Upgrading the Pacific Highway

Warrell Creek to Urunga

Submissions and preferred
project report

Part 3A Response to Submissions and Preferred Project Report

GDA 94 MGA Zone 56
A4 1:40,000

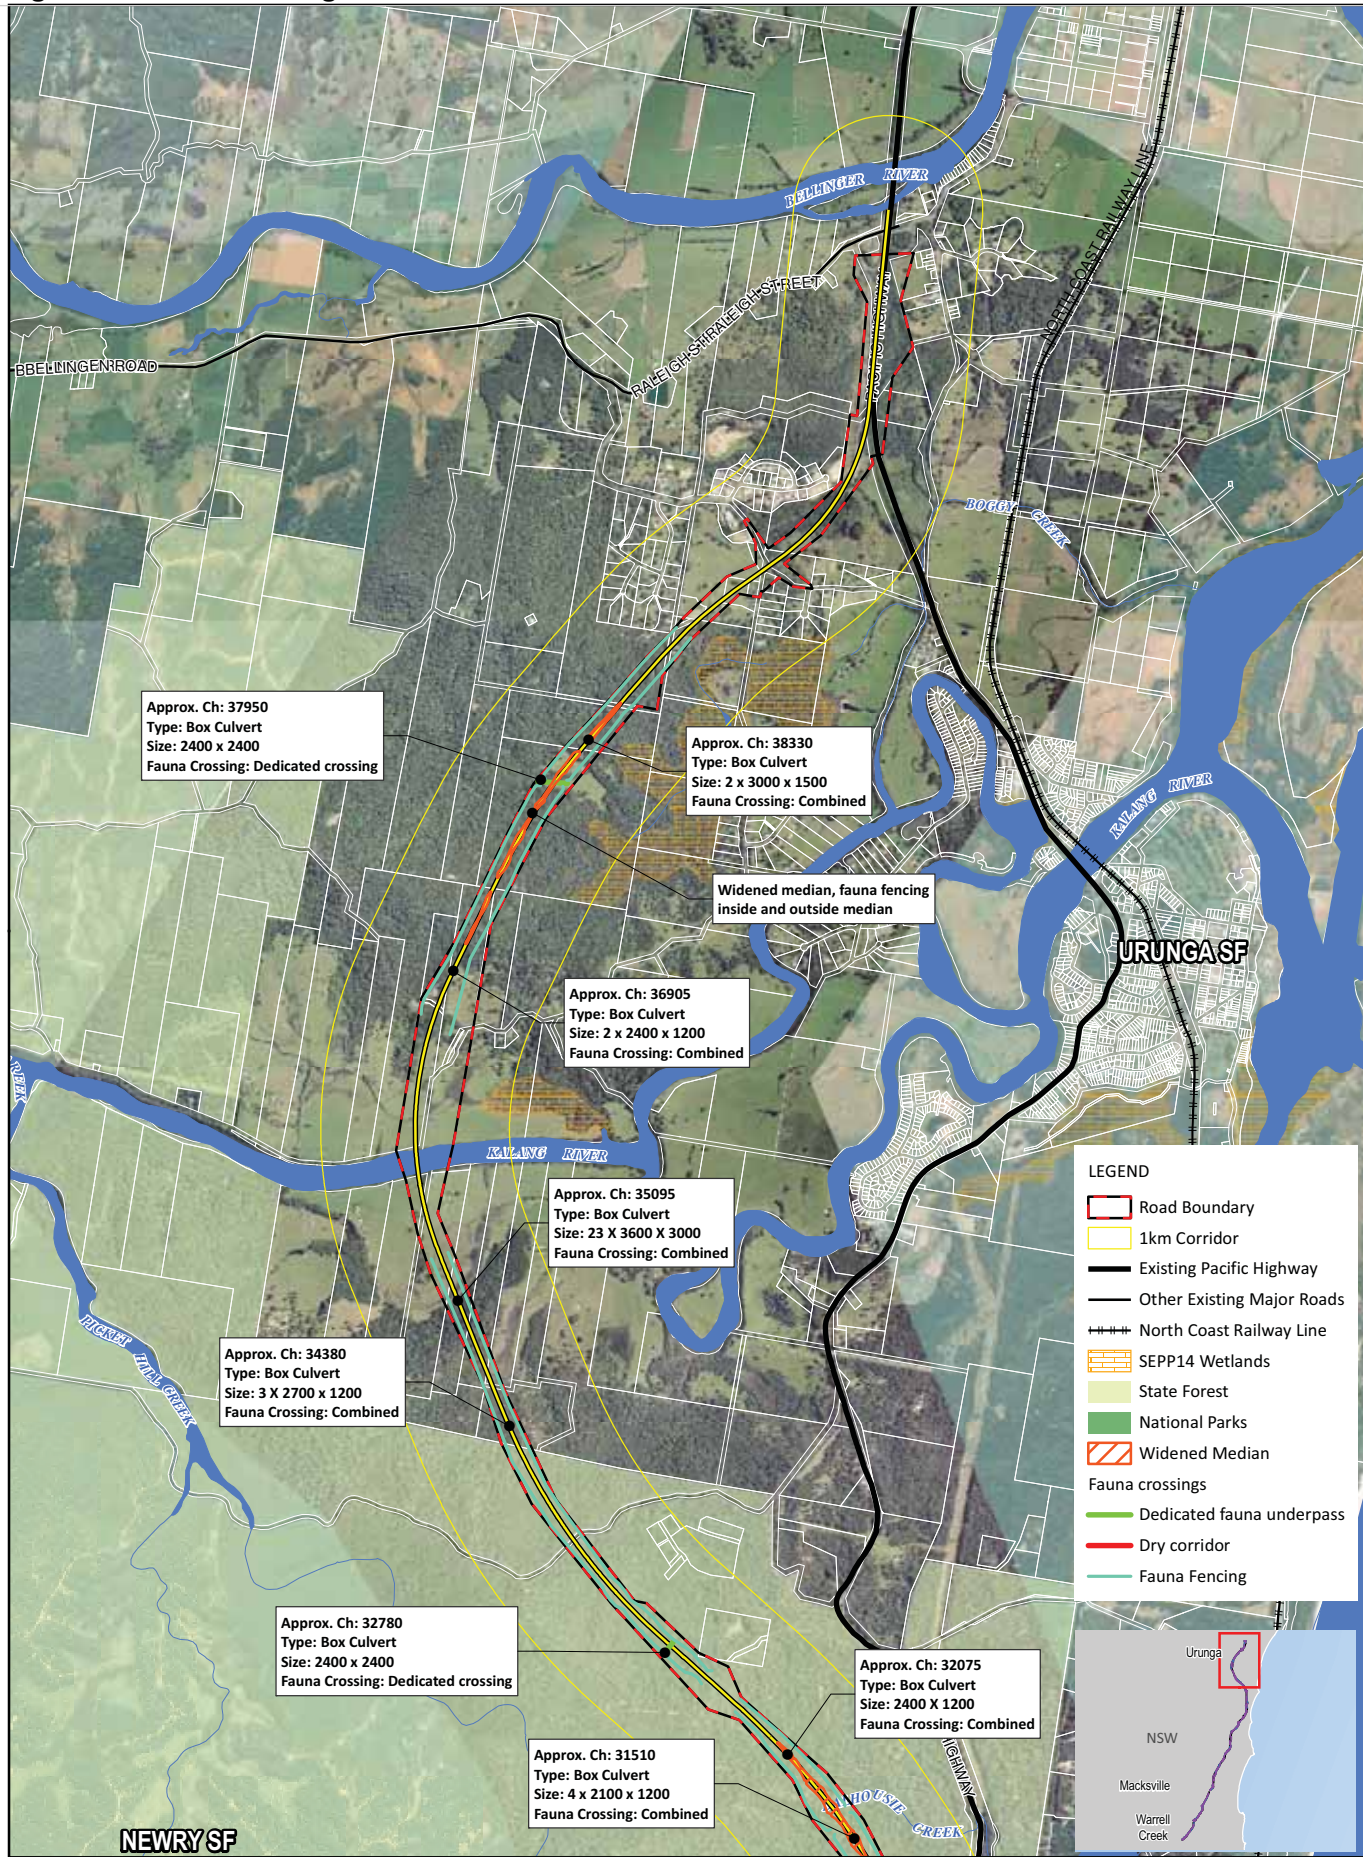
Figure 3-2 shows the details of the cross-drainage structures, where there is to be fauna fencing, along the length of the Proposal. The proposed crossings provide for both fish and terrestrial fauna movement. Fauna fencing is proposed to direct fauna to fauna crossing structures and to prevent access to the road corridor.

There are several dedicated fauna crossings within key wildlife corridors. A dedicated fauna underpass is proposed for each Newry and Nambucca State Forests and a dry fauna corridor through vegetated areas to the north of the Kalang River. In addition combined fauna crossings are proposed along the entire length of the Proposal.

Widened medians are proposed throughout the Proposal (including Nambucca State Forest (section 2), Newry State Forest (section 3) as well as private property in section 4). These have been designed to maintain mature vegetation and to facilitate the safer movement of yellow-bellied gliders and other glider species across the upgrade. The length of widened median proposed to assist with fauna crossing totals two kilometres.

Note: Fauna fencing locations are indicative to be refined at detailed design in consultation with DECCW

Figure 3-3 - Oyster Creek crossing

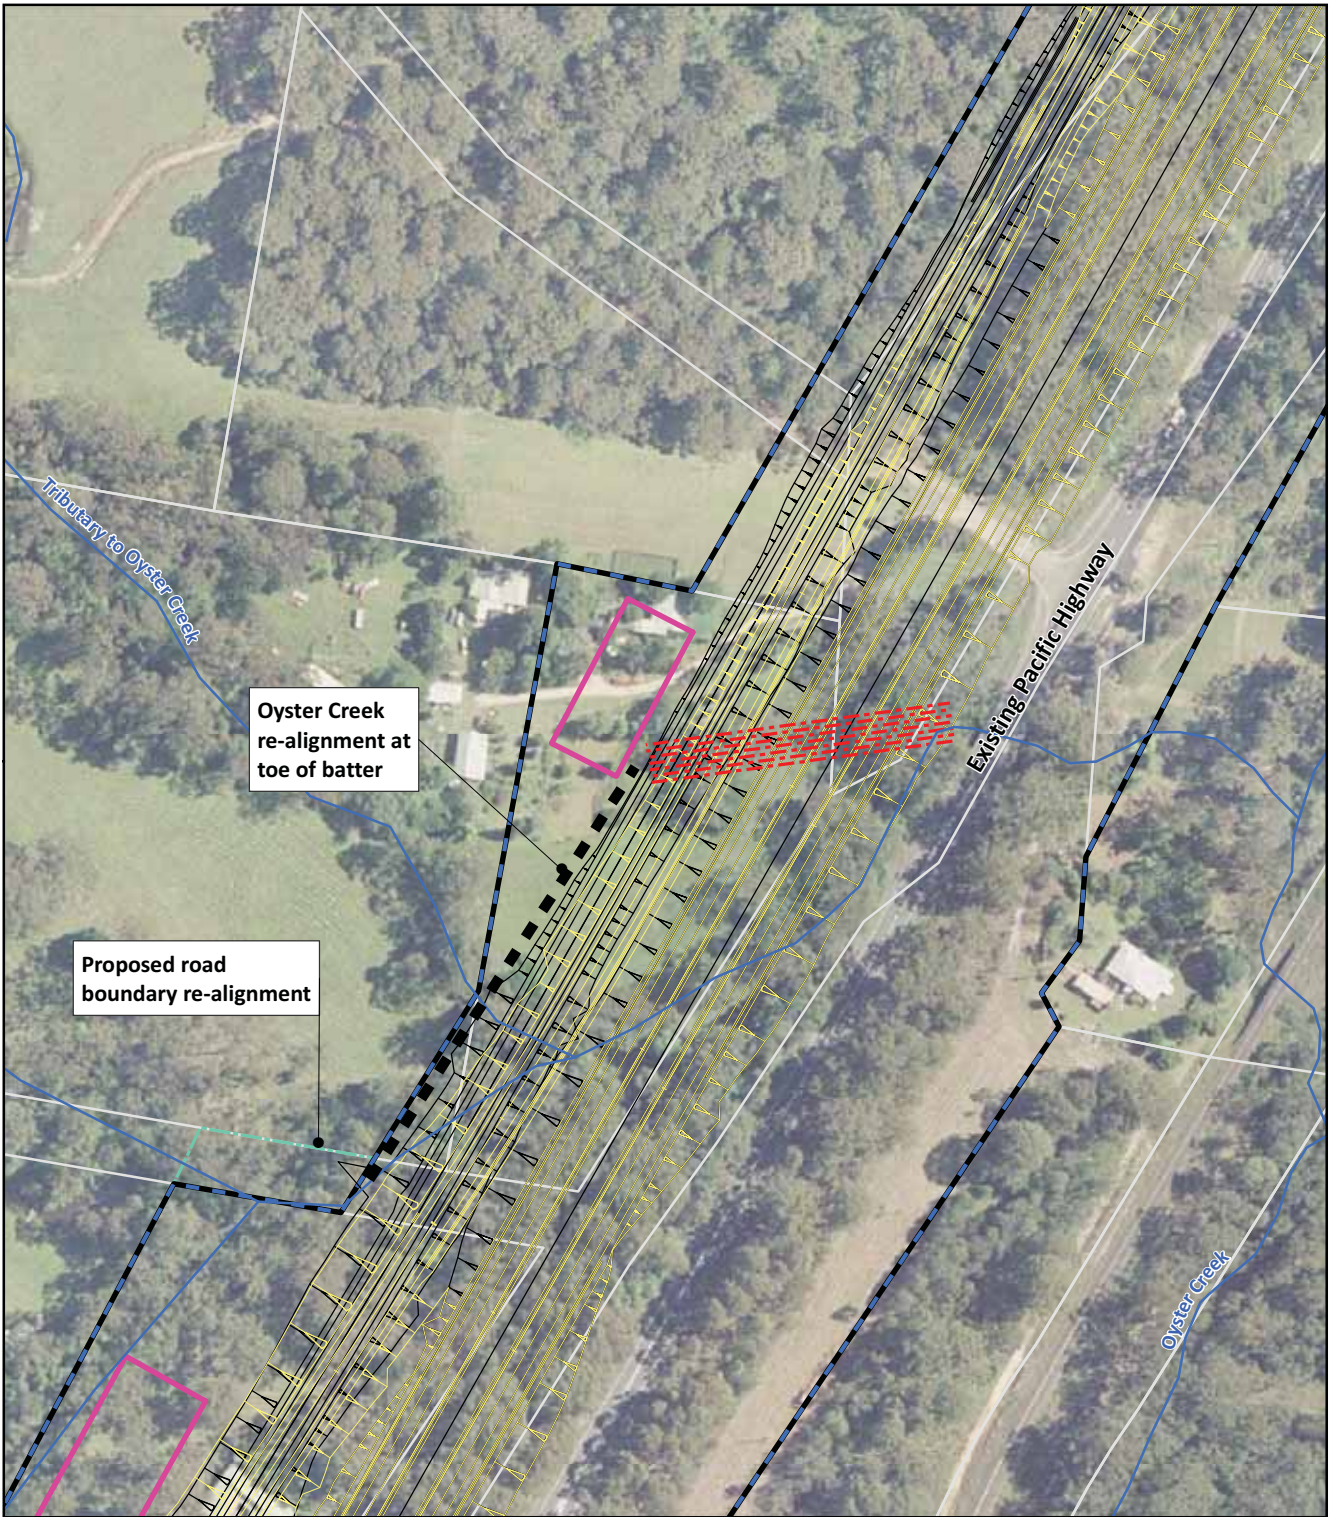
The road boundary has also been adjusted to incorporate acquisition of an additional area of Crown road to avoid the need to acquire additional land from property 137 (see figure 11-5g of the environmental assessment). Figure 3-3 shows the adjustments in relation to the Oyster Creek crossing.

Figure 3-4 - Quarry access

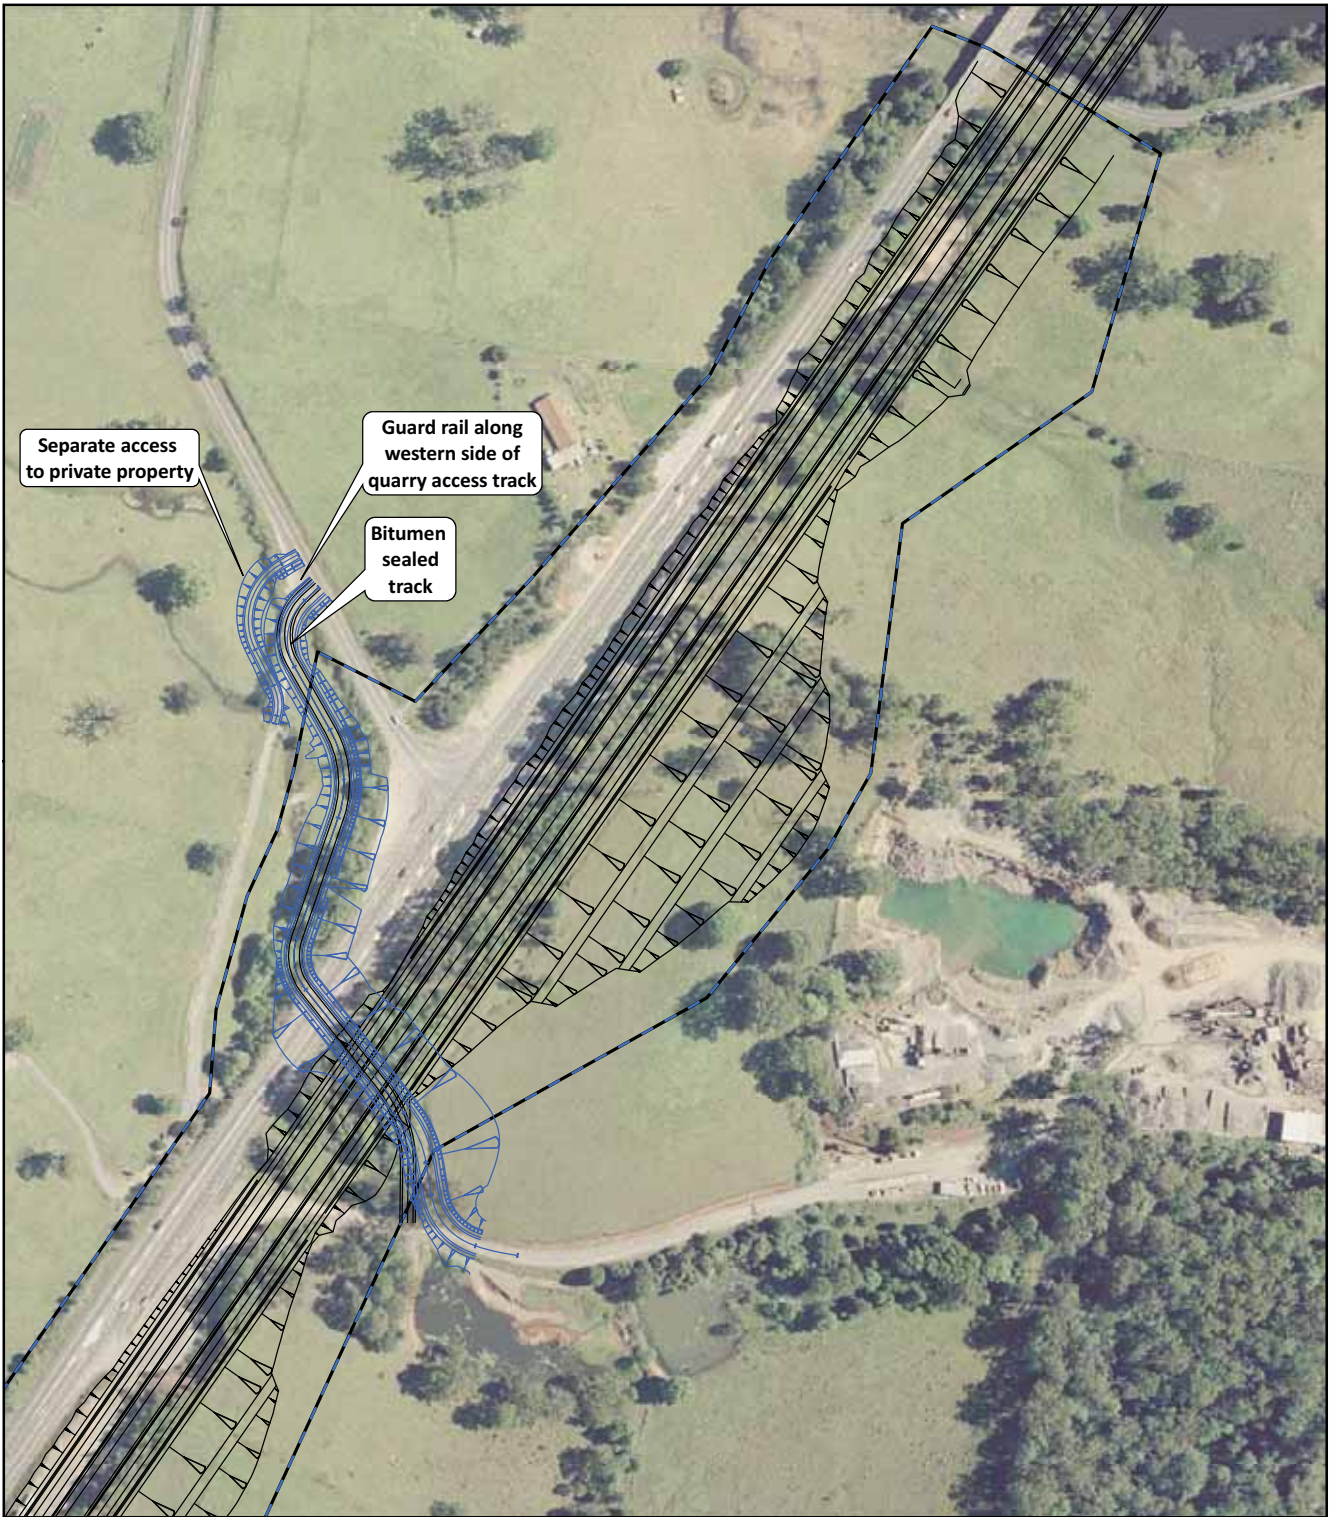
Concerns were raised by a community member regarding the potential shared access with quarry trucks in the vicinity of Nambucca Quarry. As a result the design was modified to include a bitumen sealed access track and guard rail on the western side of the access track.

Figure 3-4 shows the refined design in this location.
